Access Compliance Report Public Rights-of-Way (Pedestrian Signals)

Main Street: **E_SPRING_ST** Cross Street: **HEWES_ST** Location: **NW**

ADA ID: **SGAT210929091340** Signal Type: **One Push Button-Non APS** Overall Compliance: **No** Severity Scores: **BTN 1: 10** **BTN 2: N/A** **No BTN: N/A**

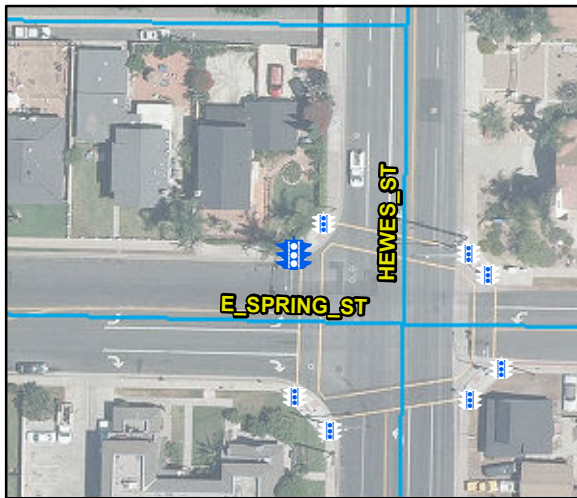
Possible Solutions: Replace Signal Push Button With APS Button.
